CITY PLANNING COMMISSION

- APPLICATION:
1. Environmental Determination
 2. Tentative Map to create a 1.4± ac. airspace lot for condominium project
 3. Special Permit to develop 24 unit airspace condominium project in R-3 zone

LOCATION: Northwest corner of Meadowview Road and Coral Gables Court

PROPOSAL: The applicant is requesting the necessary entitlements to develop a 24 unit one-story condominium project on a 1.4± vacant acre site in the R-3 zone.

SITE PLAN

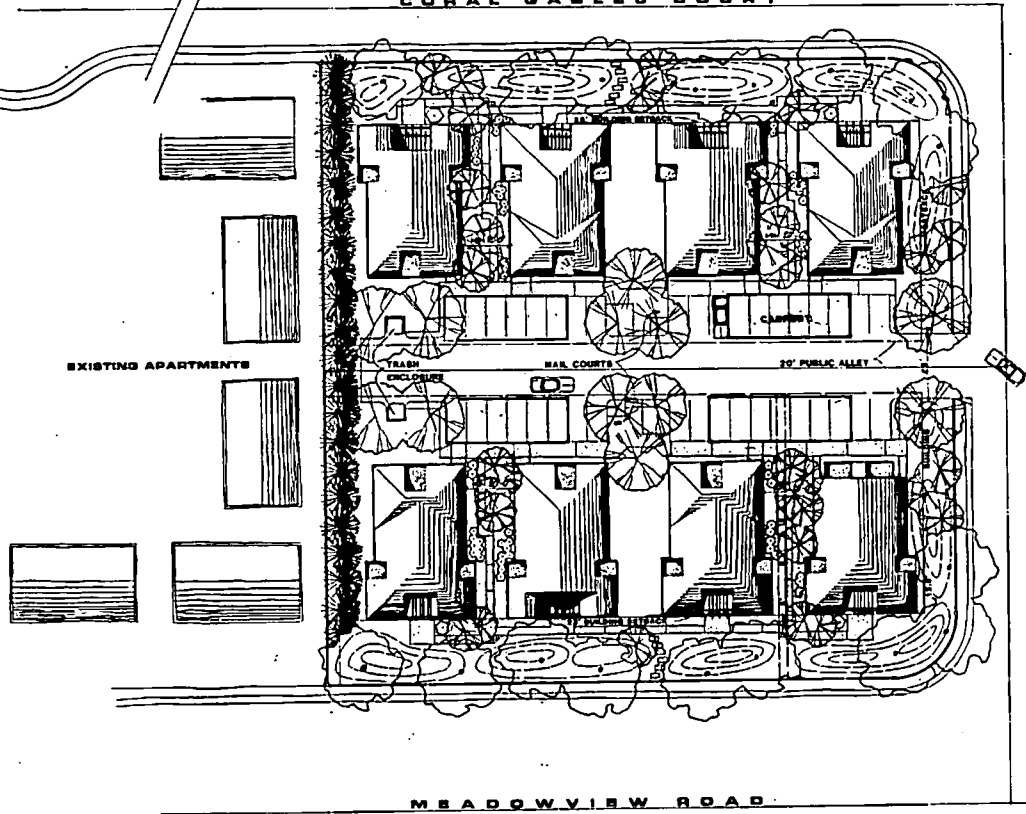
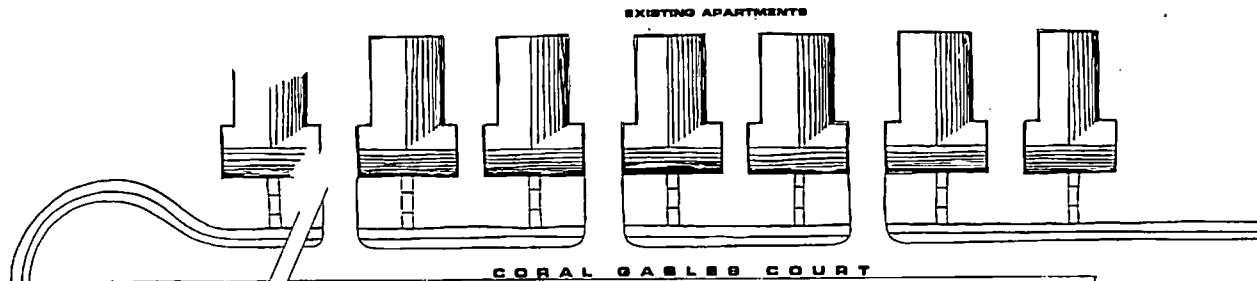
7. The site plan indicates south wall solar access for approximately 50% of the units. Staff believes that the 80% north/south unit orientation requirement is not feasible to achieve due to the fact that the property is substantially in size (230' x 248'), the property has three street frontages and the required 25 foot setbacks limit the area that can be developed with the structure. In addition, this property was originally designed for eight separate lots with a public alley located in the center. These facts also make it difficult to design these structures to eliminate monotonous front facades and create an interesting streetscape.

- e. *The applicant shall redesign the west end of the parking area to include a play area, subject to approval by staff. (added by CPC)*
- f. The applicant shall submit detailed revised site and elevation plans, landscape and irrigation plans incorporating conditions a through e to the planning staff for review and approval prior to issuance of building permits. The landscaping shall adhere to the landscaping and design criteria of Exhibit A.

EX. E 1/11

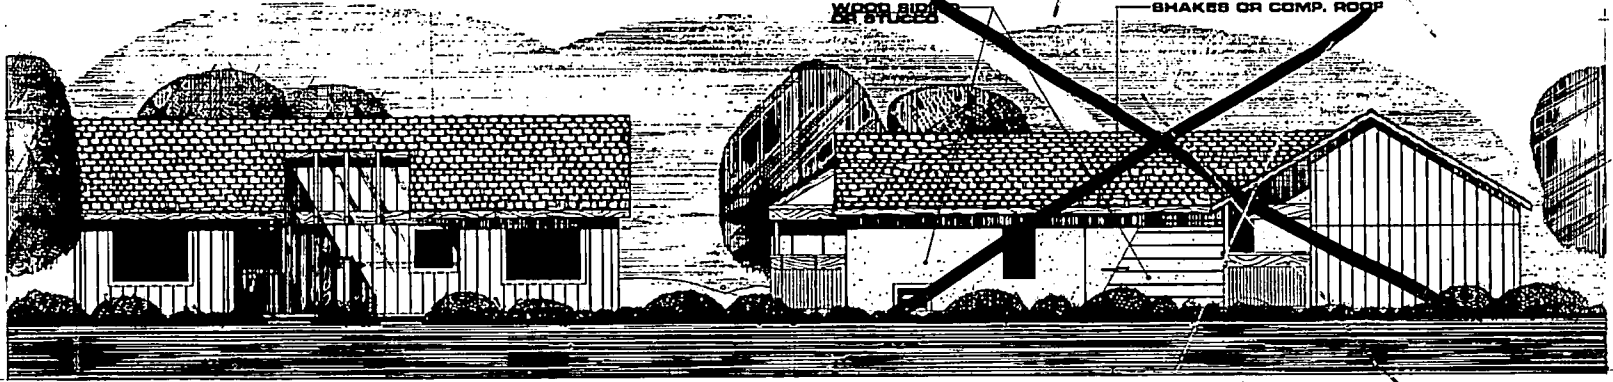
8. Staff suggests that the applicant intermix the orientation of the structures by alternating the three unit structures along each street frontage. In order to achieve south wall solar access and add interest to the structure, the wall end containing the one unit will need to incorporate window openings along the street facing walls (see Exhibit E).

ADD WINDOW OPENINGS TO PROVIDE SOUTH WALL
SOLAR ACCESS & ARCHITECTURAL INTEREST.
